ADDENDUM NO. 2
To the Plans and Specifications for:

FY25 Stormwater Improvements

City of Seminole

A. Sheet C5, Demolition & Erosion Control

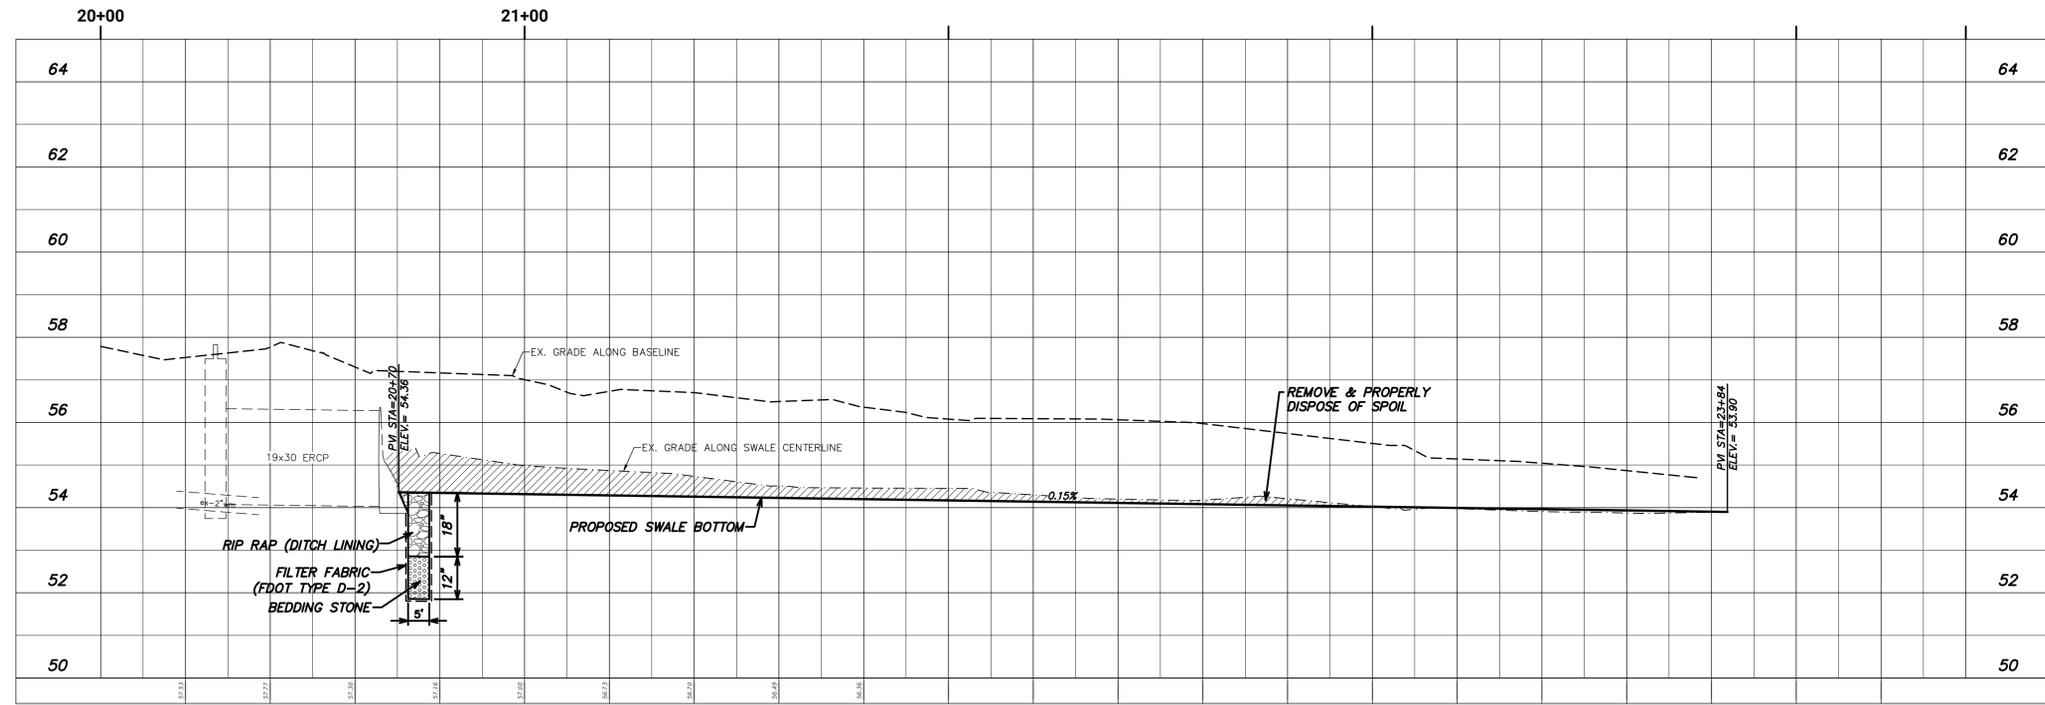
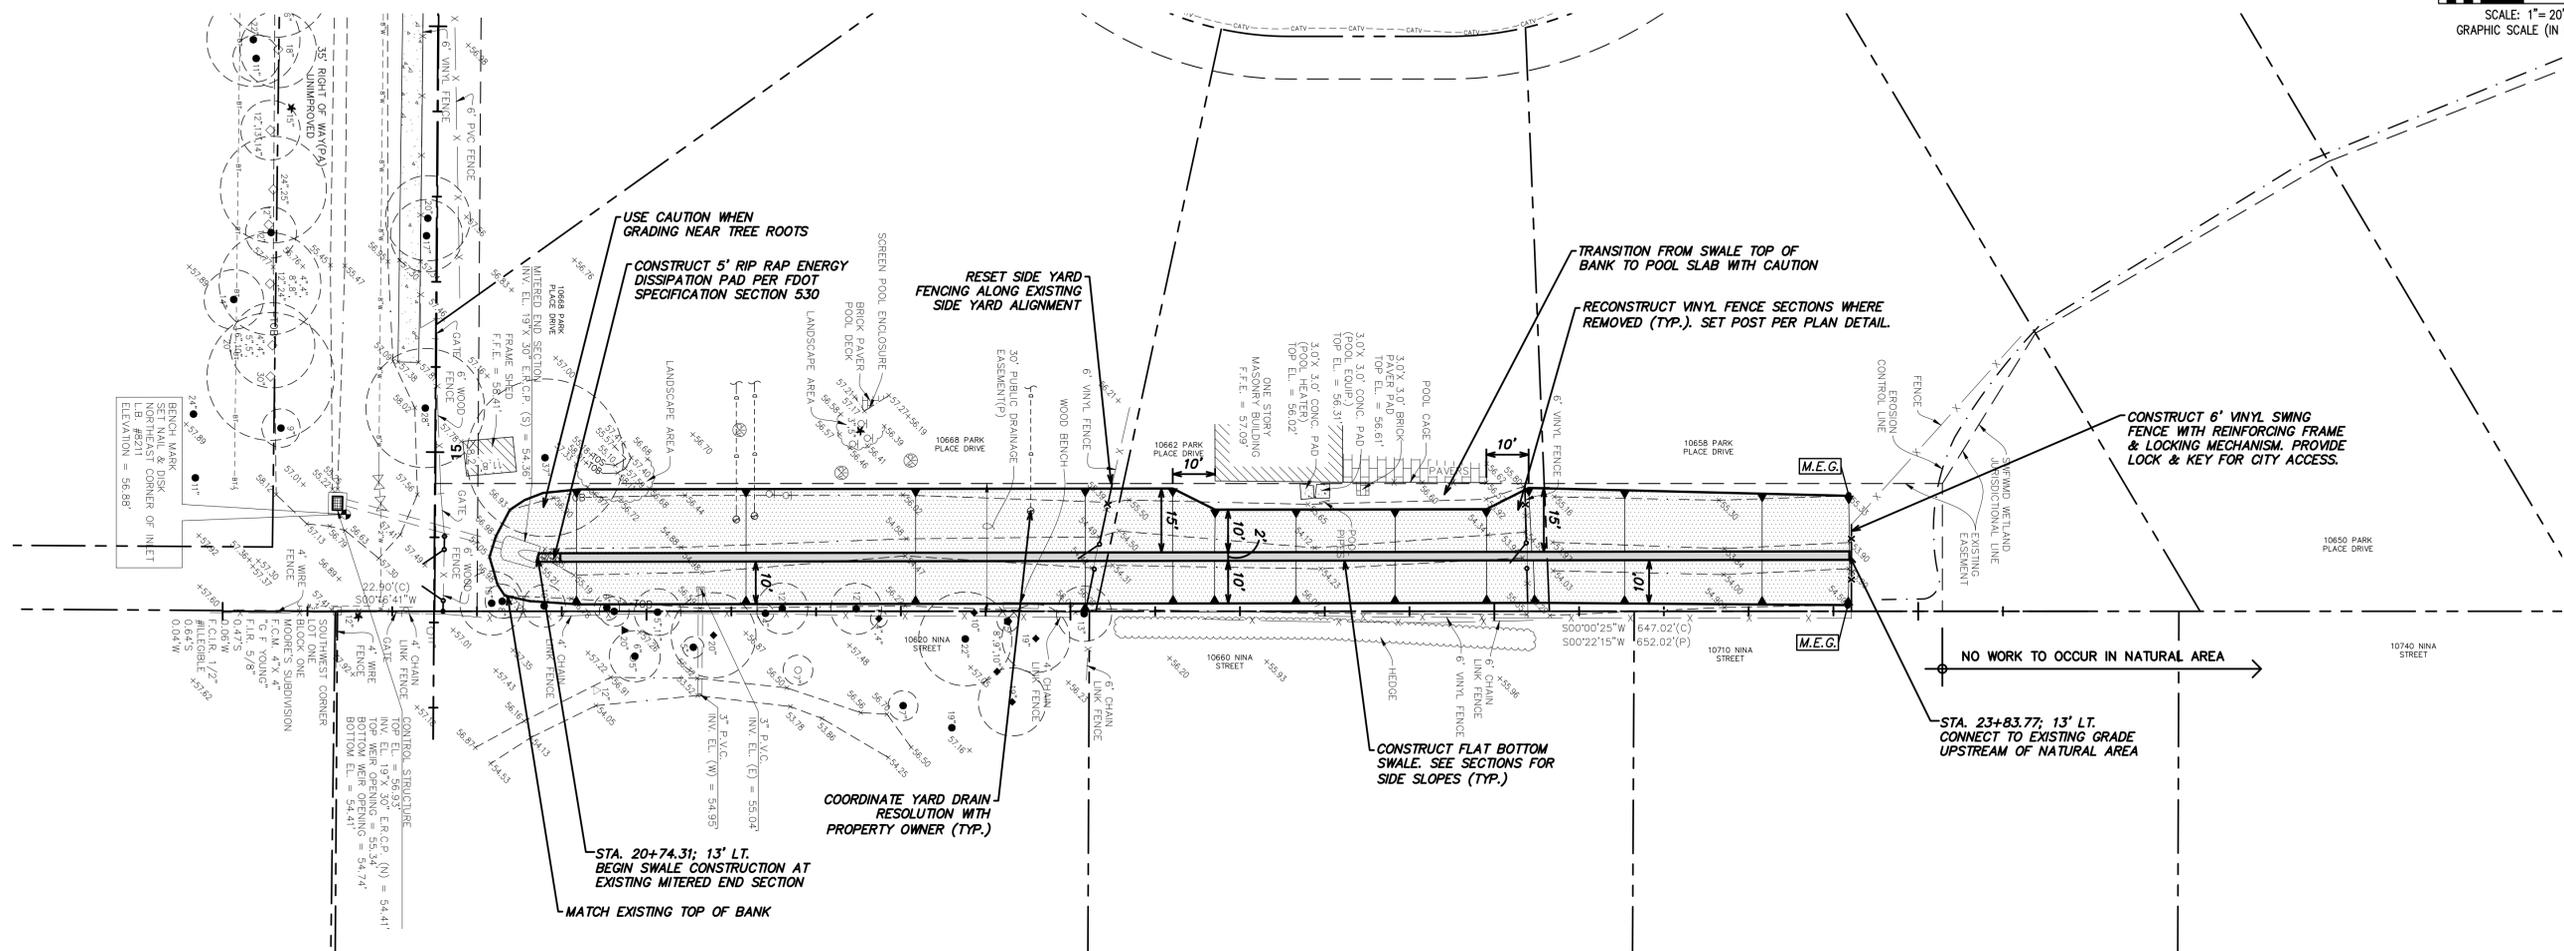
Additional silt fences and inlet protection devices have been added. The driveway is no longer being demolished.

B. Sheet C8, Plan & Profile (Baywood Park Drive)

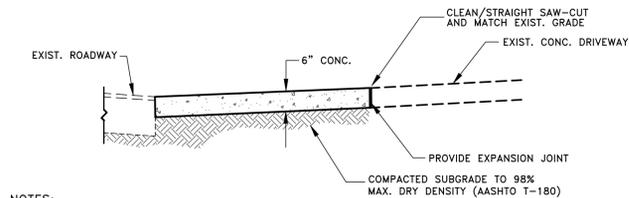
The location of the manhole structure has changed. The alignment of the sanitary sewer has been updated. A callout has been added regarding the buried electric line that crosses the street within the project area.

6 EROSION CONTROL DEVICES
NOT TO SCALE

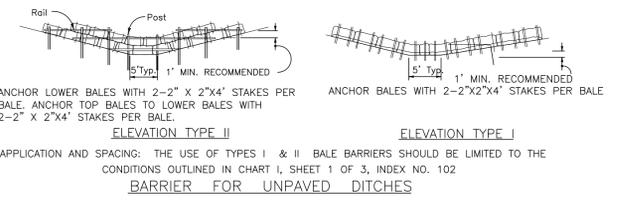
The detail for Residential Driveway Dimensions was removed. Details for Erosion Control Devices and Tree Protection were added.

8 BARRIER
NOT TO SCALE

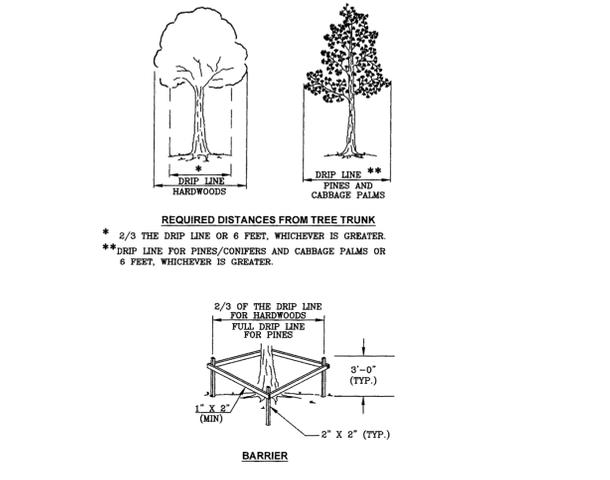
RSQ.7 Is a tree barricade detail available?

Please refer to the details on the revised C10.
